BAY AREA
AIR QUALITY
MANAGEMENT
DISTRICT

Final Determination of Compliance

Marsh Landing Generating Station Contra Costa County, CA

Bay Area Air Quality Management District
Application 18404

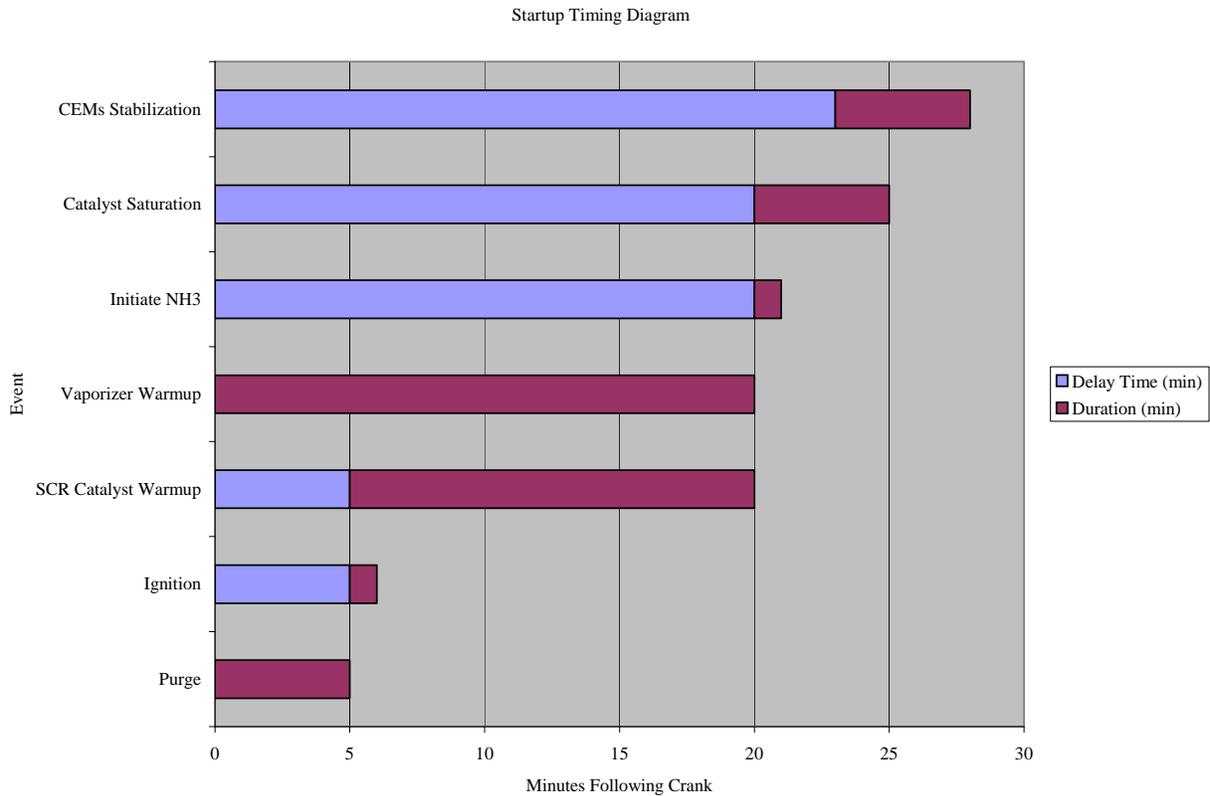
For startups, the District's initial limits in the PDOC were based on (i) an emission estimate from Siemens showing that NO_x emissions during a turbine startup would be 12 pounds (*see* Siemens Estimate dated March 27, 2008 in Appendix D of the FDOC), and (ii) information from an SCR vendor that the SCR system would be expected to be up to temperature and fully functional as soon as the turbine startup was complete 11 minutes after fuel is first introduced.² For the PDOC, the District anticipated that it could potentially take up to 30 minutes for the startup to be completed and for emissions to come within the steady-state NO_x emissions limit of 2.5 ppm under a worst-case scenario, but based on the information outlined above it conservatively assumed that emissions would be no worse than if the turbine had 12 pounds of emissions in the first 11 minutes and then emissions at 2.5 ppm for the rest of the 30-minute startup.

The current information from Siemens and the SCR vendors shows that the basis for the District's original analysis was incorrect. The new information shows that Siemens' current estimate for NO_x emissions during a turbine startup is 14 pounds, not 12 pounds, (*see* Siemens Estimate dated March 22, 2010 in Appendix D of the FDOC); and (ii) that the SCR system may take as long as 28 minutes to come up to temperature and start to become effective in reducing NO_x emissions.^{3,4} The reasons why the SCR system may take this long to begin operating effectively can be seen in the startup timing diagram set forth below, and include time needed for the equipment to warm up, for ammonia injection to be initiated and for the catalyst to become saturated, and time needed for the CEM to stabilize.⁵
